INSTRUCTION TO SERVICE

ITS: 2271

Shorten and re-orientate transmission cooler line.

Figure 2. Transmission Cooler Line Installation

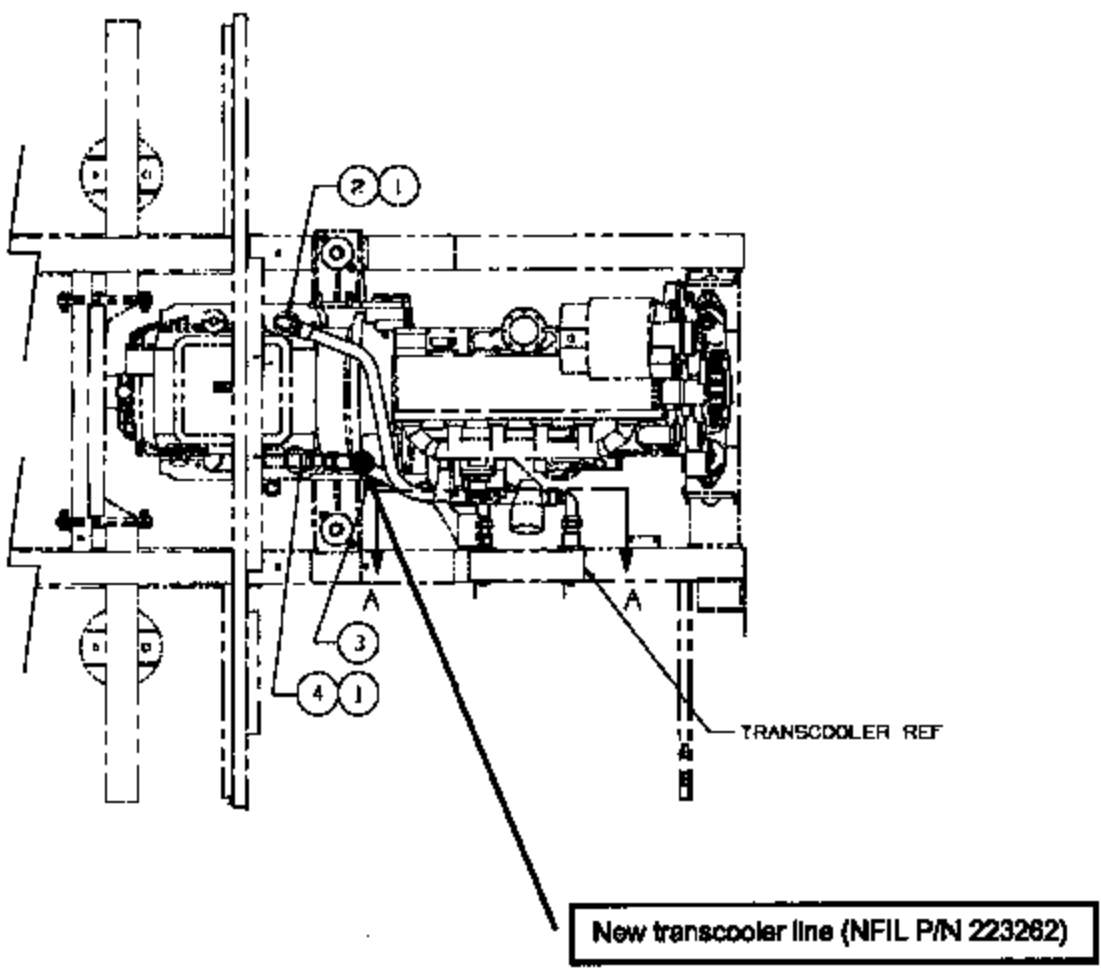
8. Install new transmission cooler line (NFIL P/N 223262) between transmission and transmission cooler. Orientate line so that 90-degree adapter is on transmission port. Refer to Figure 2.

Note: 90-degree adapter facing to rear of coach and 45-degree fitting directing new hose upwards.

Note: This end (90-degree) of the transmission cooler hose points to roadside of coach for mating with transmission cooler.
